# 2 LOT SUBDIVISION PLAN FOR

# DUBE PLUS CONSTRUCTION,

TAX MAP 283, LOT 11 HEMLOCK WAY, PORTSMOUTH, NH 03801 ROCKINGHAM CO.

**TAC Notice of Decision Response Comments**

**PGP** SHT. 4 of 10

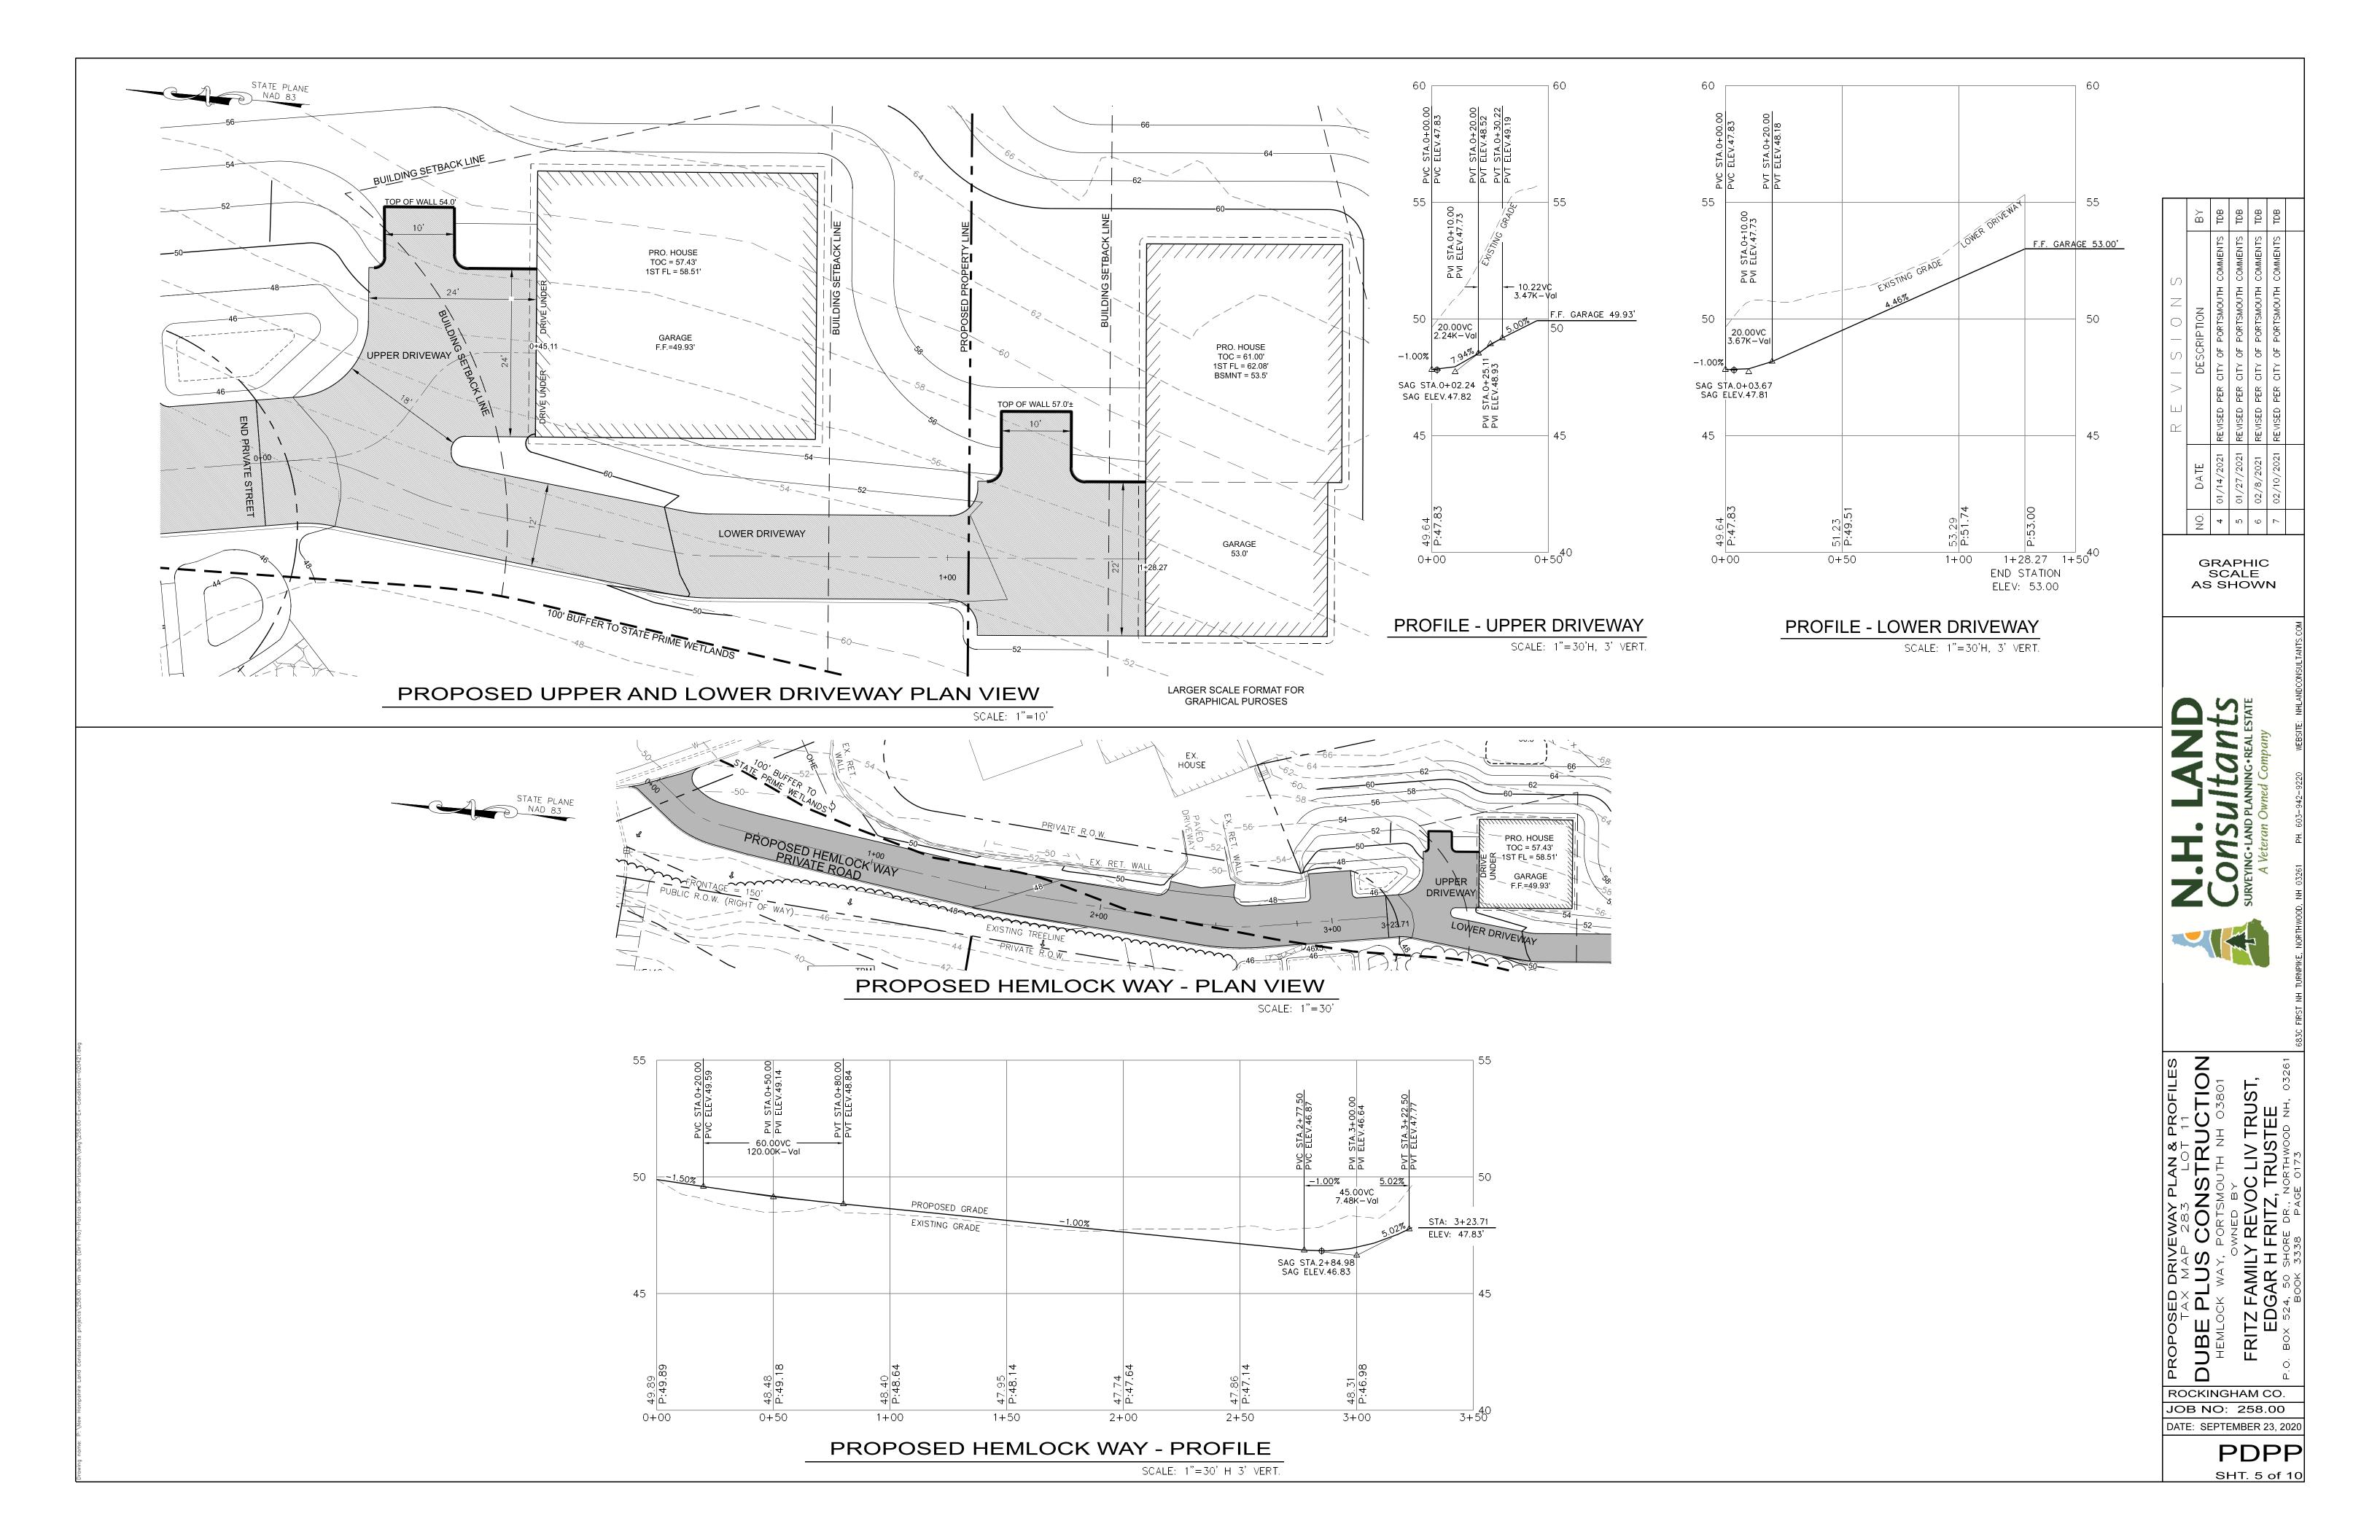
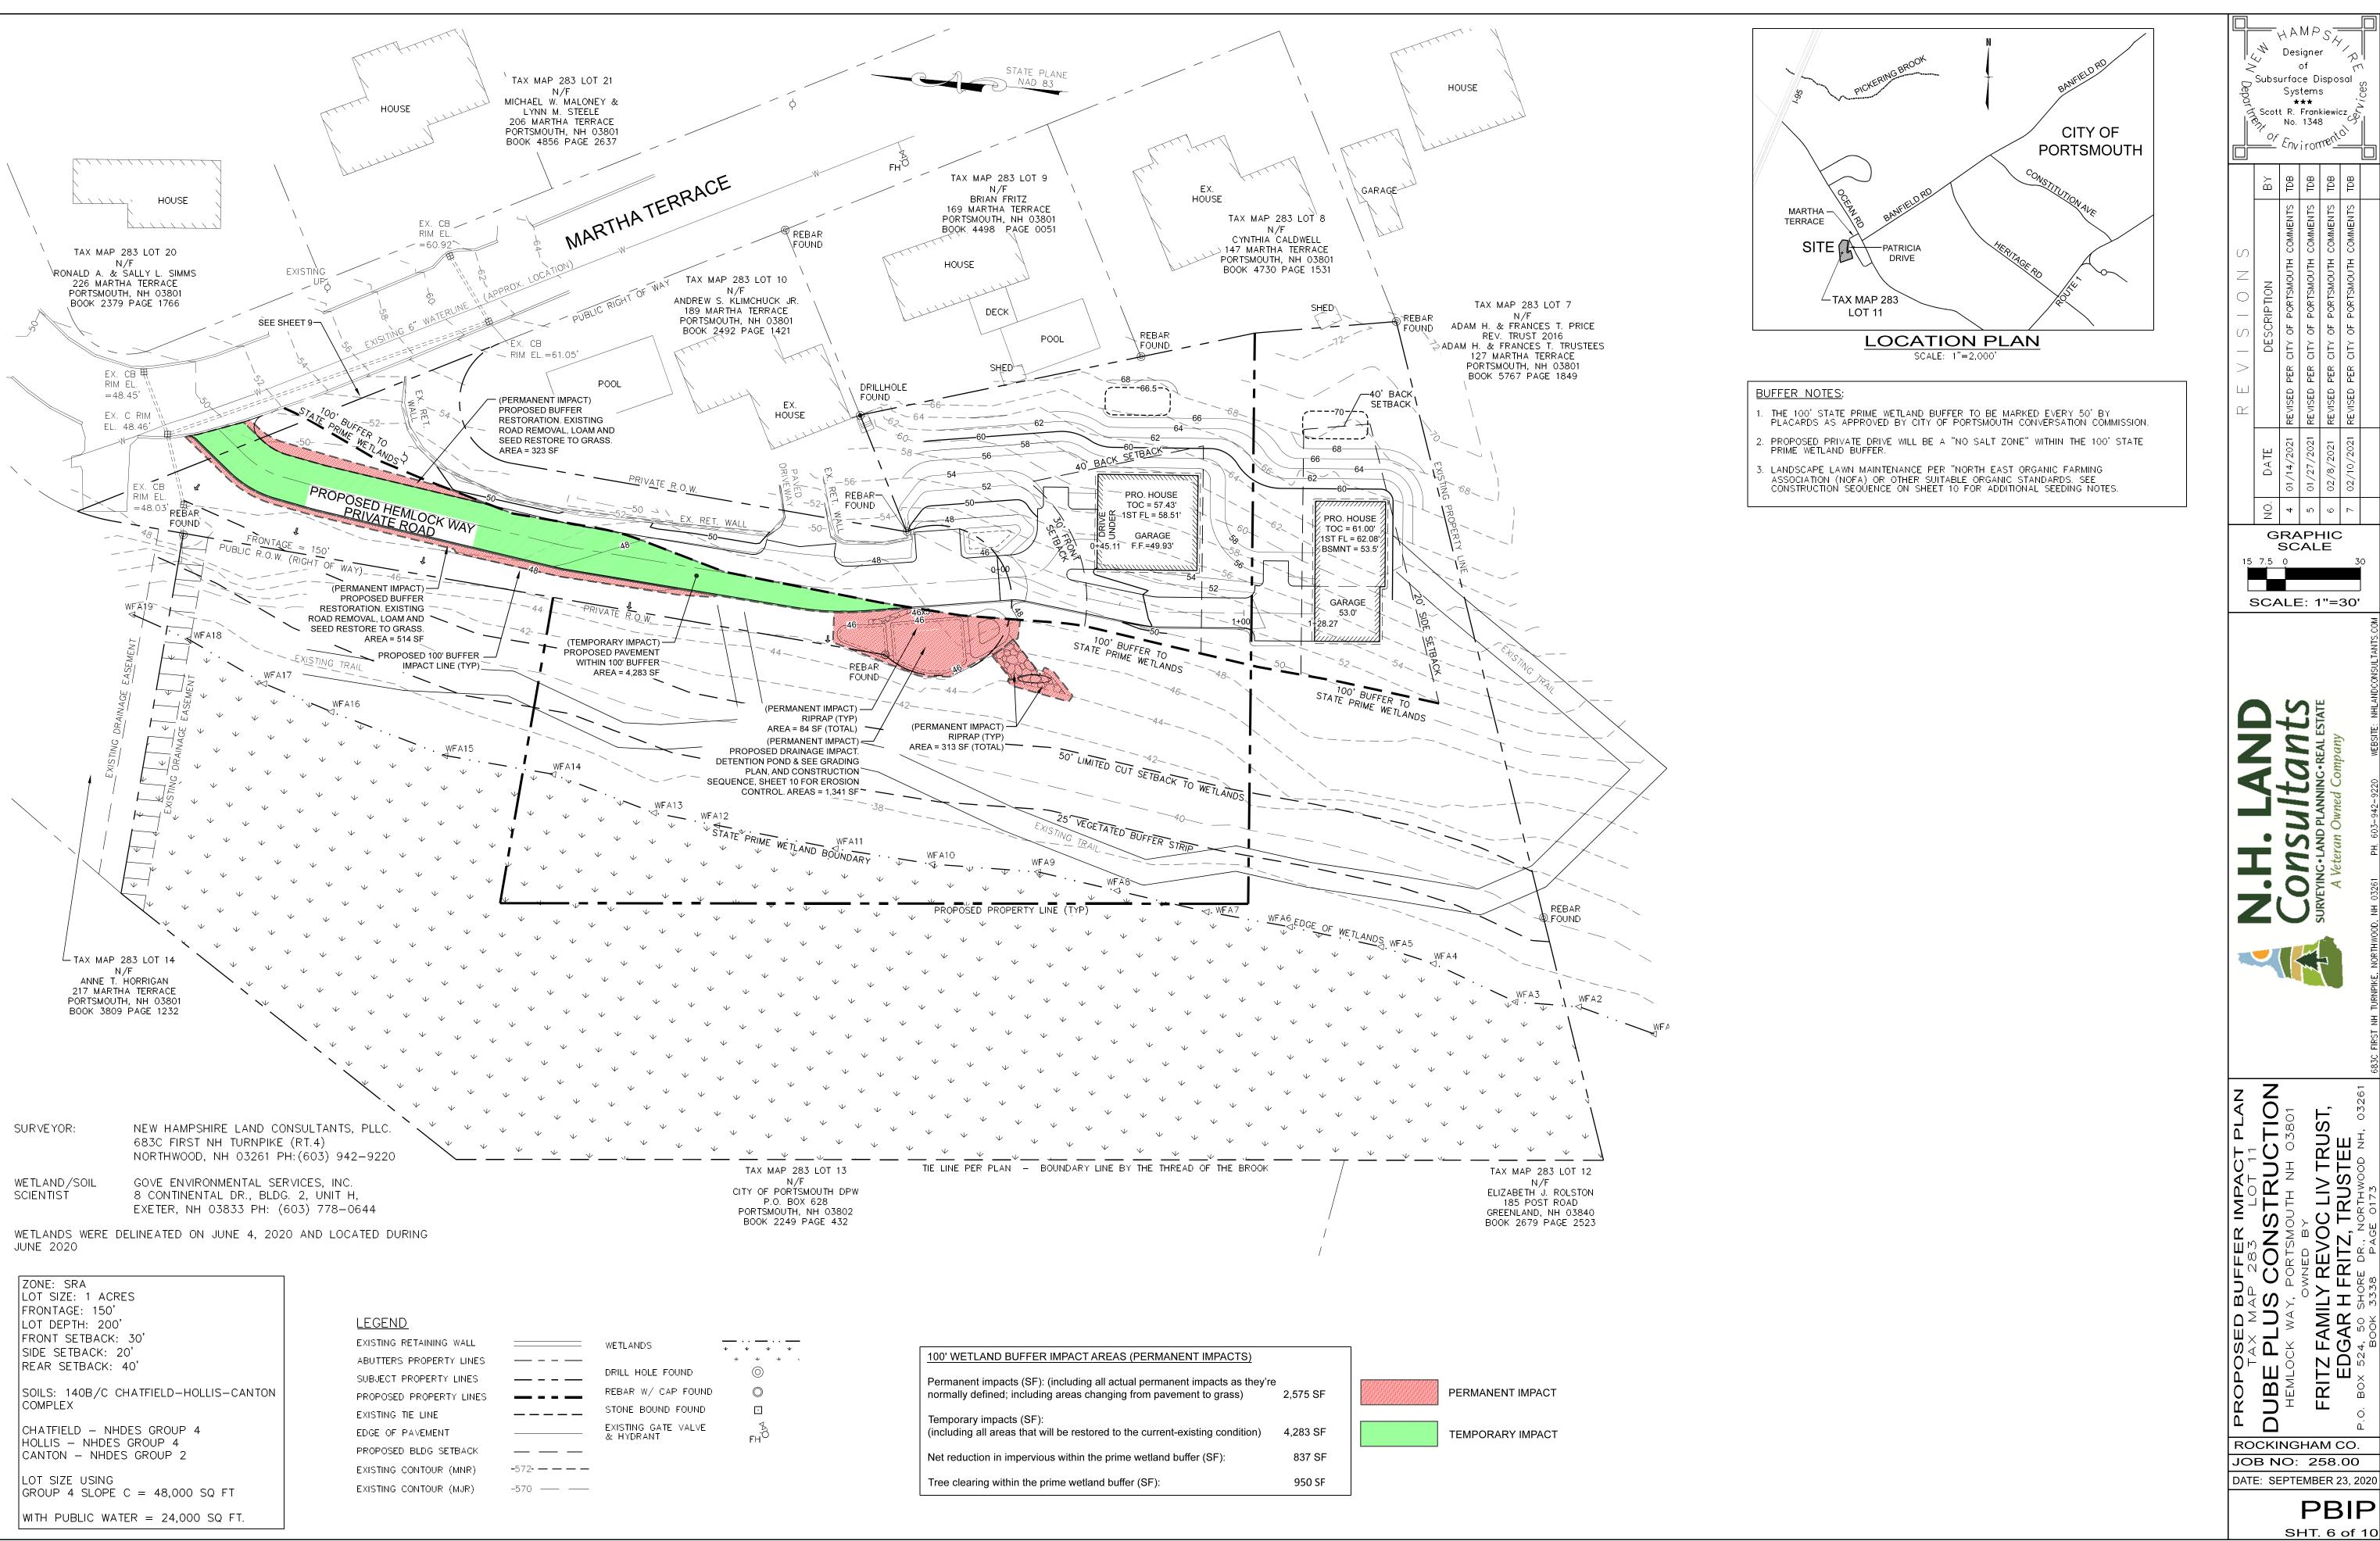
4. The drainage for the shared driveway should be upgraded to provide infiltration or some other approved method of treatment.

6. The plan label should be updated to "Street" rather than "Drive" and the applicant should include the proposed name of the street for consideration by the Planning Board.

8. Plans shall be updated to correct driveway access and turnarounds. The upper driveway is short and connects to the main drive at an odd angle. It will be difficult for vehicles to enter or exit the garage closest to the retaining wall.

5. Revise cross section detail on sheet 4 of 10 per sketch.

Response: The plans have been revised changing the detention pond to an infiltration basin (rain garden) as shown on Sheet 4 of 10.

Response: The plans have been updated to reference STREET (see sheet 4 of 10). The proposed road name – Hemlock Way – has been added to the plan set on several sheets.

Response: Proposed driveways have been revised to show adequate access/egress with proper turnarounds (see sheet 4 of 10).

Response: See sheet 4 of 10 for the revised detail as requested.
